November 2, 2018

Serial: RA-18-0178

Brunswick Steam Electric Plant, Unit Nos. 1 and 2  
Renewed Facility Operating License Nos. DPR-71 and DPR-62  
Docket Nos. 50-325 and 50-324

Subject: Response to NRC Request for Additional Information (RAI) Regarding Application to Adopt 10 CFR 50.69, "Risk-Informed Categorization and Treatment of Structures, Systems, and Components (SSCs) for Nuclear Power Reactors"

Figure 5-6  
OTHER EXTERNAL HAZARDS

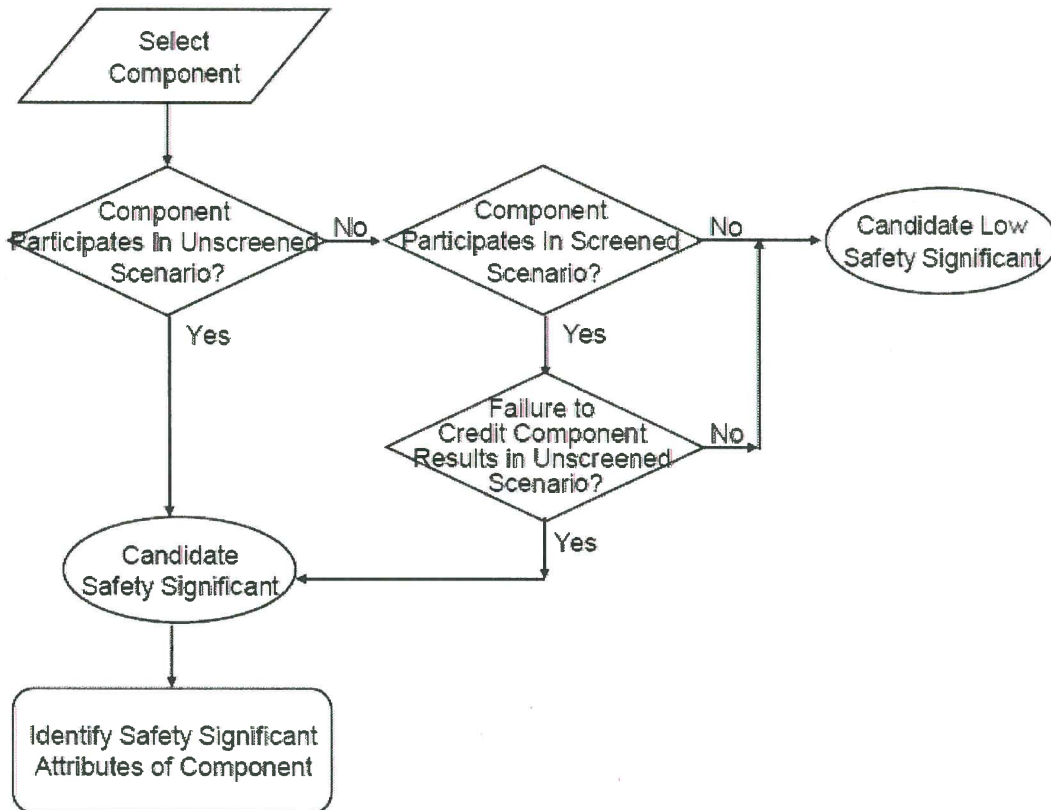
The last sentence implies that the assessment has been completed and concludes that all other external hazards will never need evaluation during categorization. The individual plant examination of external events (IPEEE) screening process did not include the additional step illustrated in Figure 5-6 in Section 5.4 of NEI 00-04. Figure 5-6 and its associated text states that an evaluation is performed to determine if there are components being categorized that participate in screened external event scenarios whose failure would result in an unscreened scenario.

Please clarify how the screening criteria in LAR Attachment 5, "Progressive Screening Approach for Addressing External Hazards," satisfy the guidelines that HSS will be assigned to SSCs whose failure would cause a screened external event scenario to become unscreened.

**Duke Energy Response to PRA RAI 7:**

The screening criteria in Attachment 5 of the LAR were used to determine those external hazards listed in Attachment 4 of the LAR requiring a PRA model for this application and those screened from needing a PRA model. The LAR Attachment 5 denotes the screening criteria that determines "screened scenarios" versus "un-screened scenarios".

Per NEI 00-04 the external hazard assessment is required for each SSC categorization. As such, each SSC being categorized will be assessed in accordance with NEI 00-04 Figure 5-6 for the external hazards listed in Attachment 4 of the LAR. If the failure of the SSC results in the screening criterion from Attachment 5 not being met, then the scenario would become unscreened and the SSC would become candidate High Safety Significant. NEI 00-04 Figure 5-6 is shown below for reference.
